Eielson Air Force Base Operable Units 3, 4, and 5

Declaration of the Amended Record of Decision

**AMENDMENT OUTLINE
OPERABLE UNITS 3,4,5 RECORD OF DECISION
EIELSON AIR FORCE BASE
SOURCE AREAS DP44, SS35, ST58, & LF03/FT09**

ST58: TI-Waiver Boundary, E on AFB, Alaska

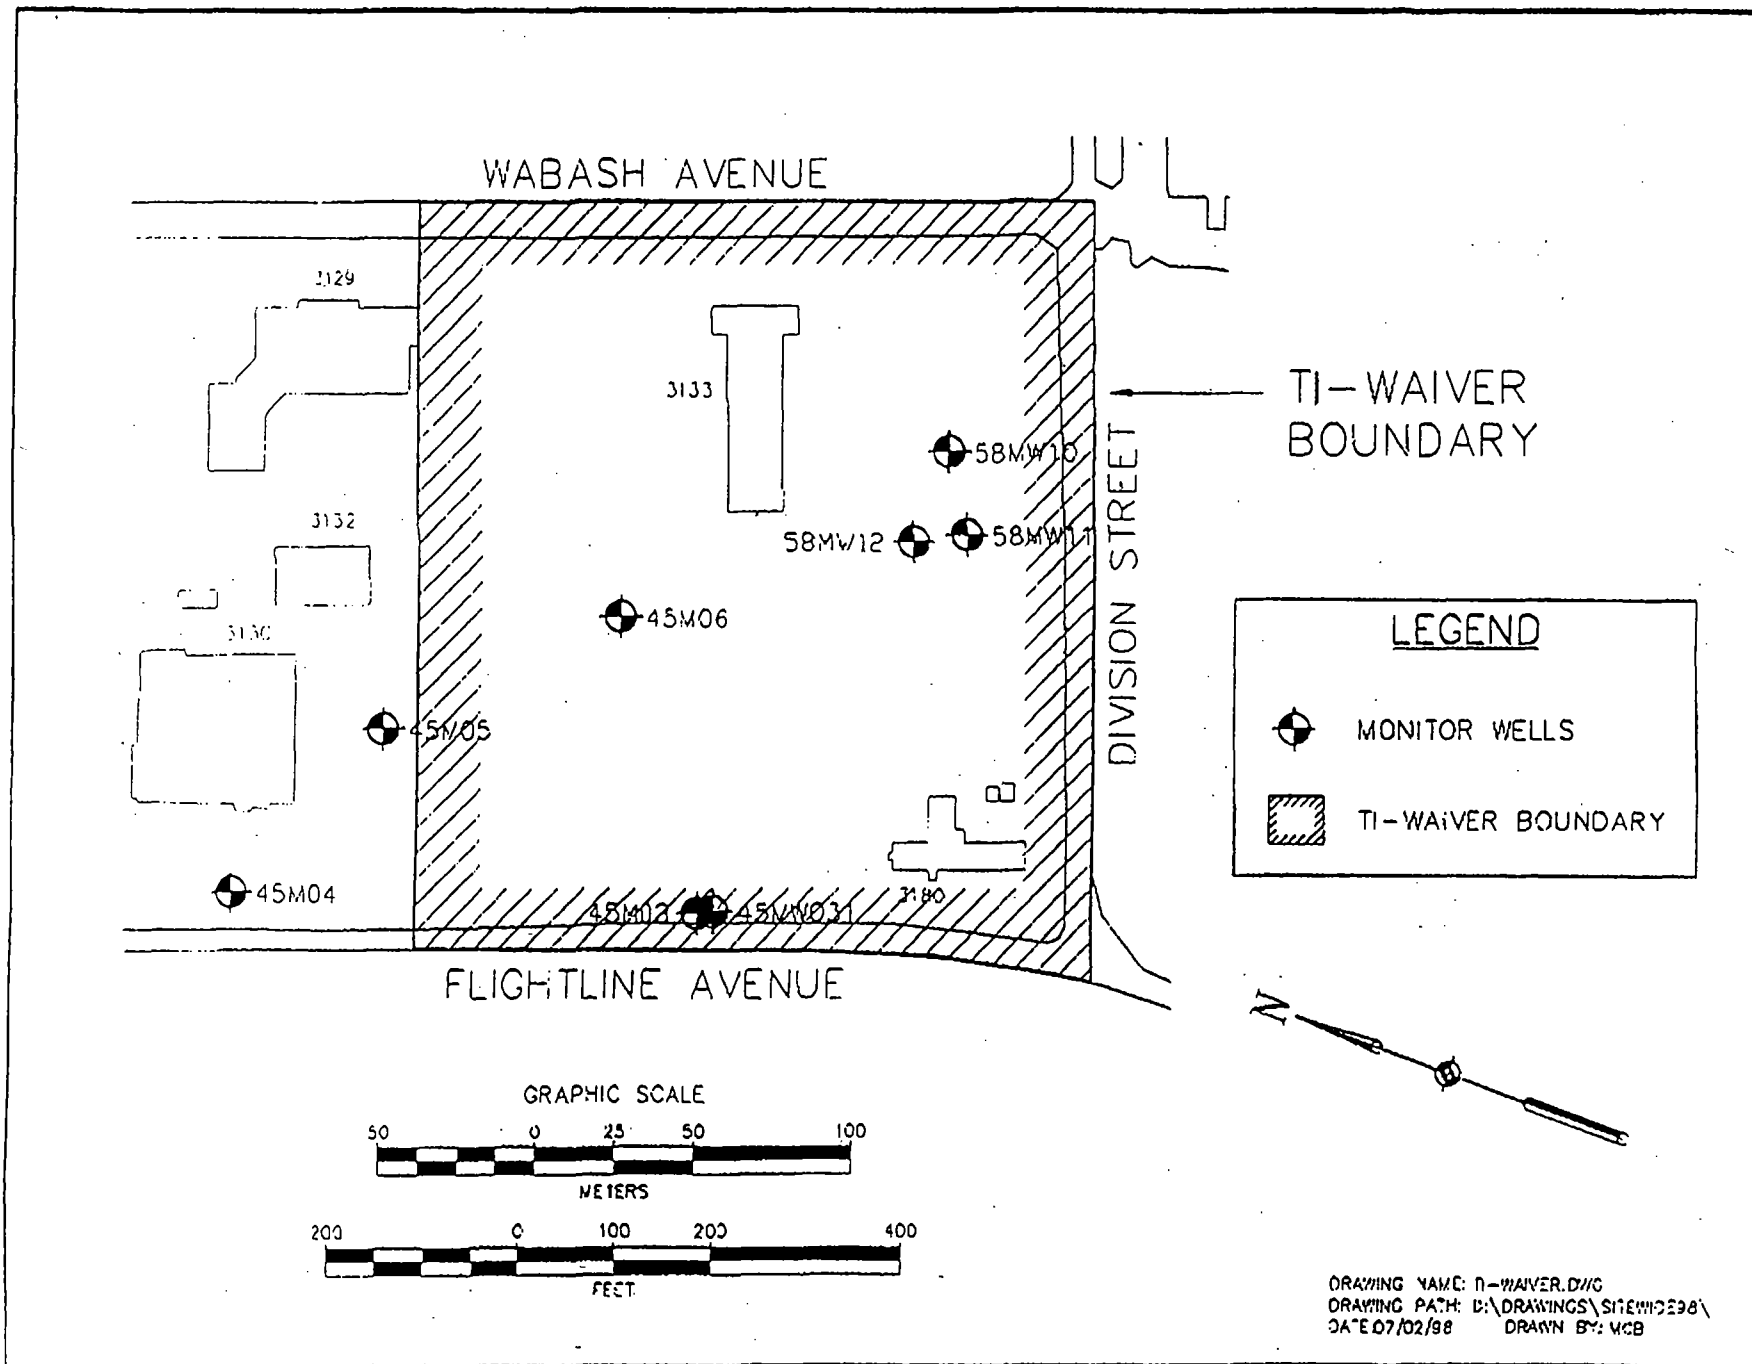
The TI waiver will apply to the area having the following boundaries (see Figure A).

FIGURE 2
CONCEPTUAL SITE MODEL
EIELSON AIR FORCE BASE

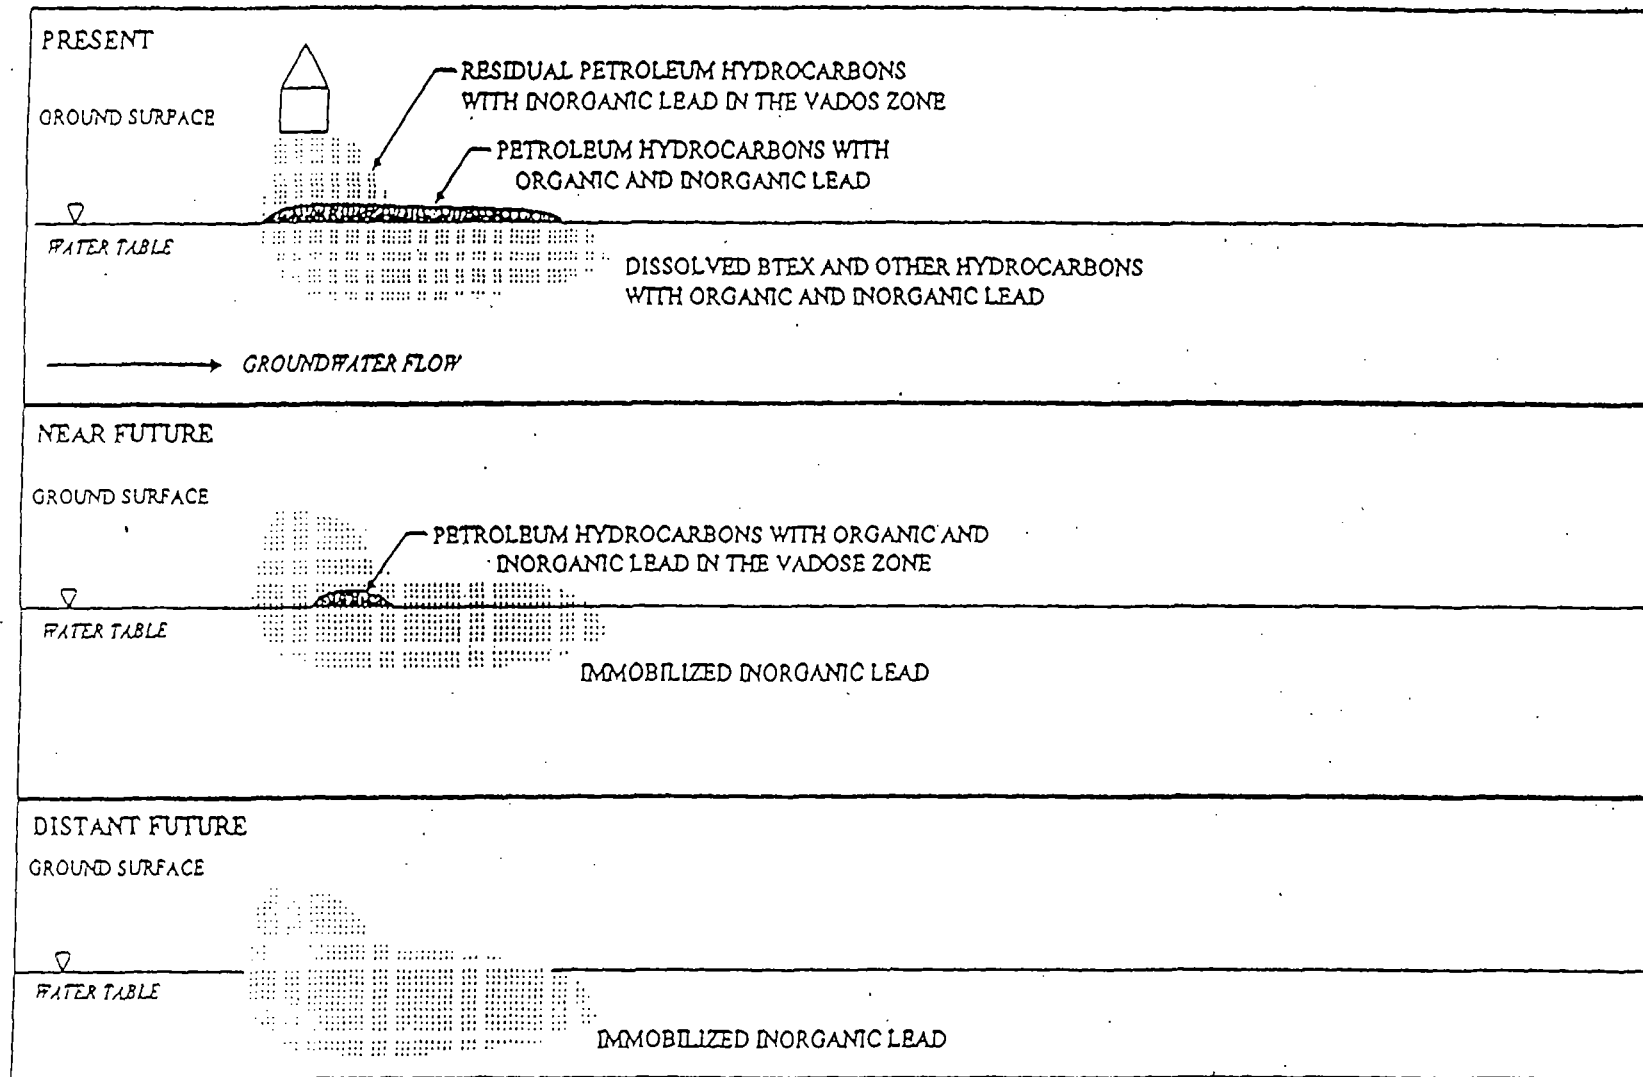
The investigation indicates that the major source of lead contamination is from the floating product plume as shown in Figure 2. The lead plume is confined to a small area north of the above ground storage tanks at DP26 and appears to coincide with the historic extent of the floating product plume. During the investigation, tetraethyl lead (TEL), the organic lead fuel additive, was detected in a floating product sample at a level of 319,000 ug/L and at low levels in the groundwater, i.e., 6 ug/L (page ES-3). The groundwater TEL plume was coincident to that of inorganic lead. The investigation also established that the lead contamination is confined to depths between 5 and 30 feet below ground surface (page 5-3).
